Comanche County-City Airport
TxDOT CSJ No. 2223COMAN

ADDENDUM NO. 1

November 7, 2022

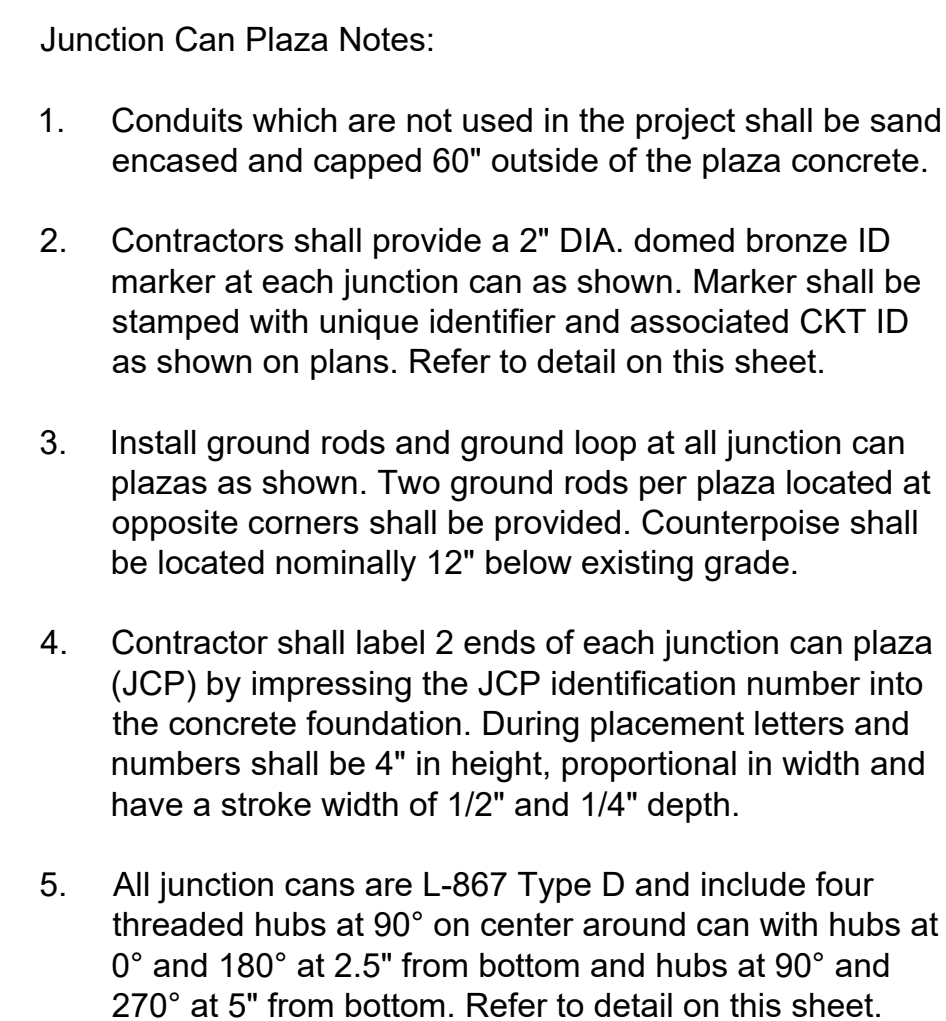
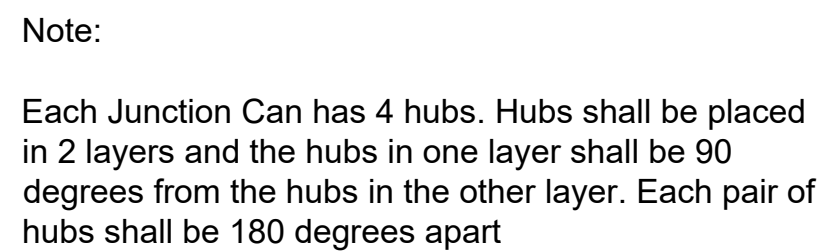
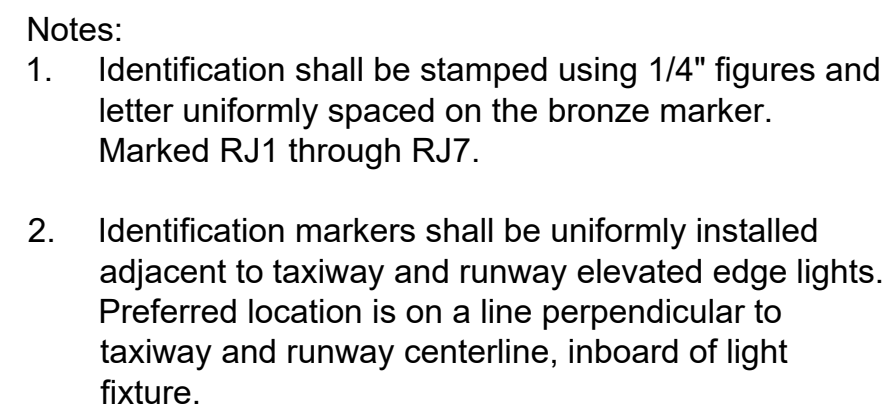
- C. You are hereby notified of the following amendments to the Construction Plans for the subject project.
 - 1. **Plan sheet E5 has been revised to include the 2 & 4-WAY 2" Schedule 40 Encased in Earth Detail.**

- a. Item 23 Bore 2 - 2" HDPE Conduit under existing paving has been added to the attached revised bid form.
9. Please provide a detail for Bid item 22, "4-Way, 2" PVC Conduit, Sched 40, Encased in Earth"

- a. Detail has been added to Revised plan sheet E5.
10. Please verify quantity for Bid item 22, "4-Way, 2" PVC Conduit, Sched 40, Encased in Earth" and confirm location of this duct bank. Is it the highlighted run below (sheet L1)
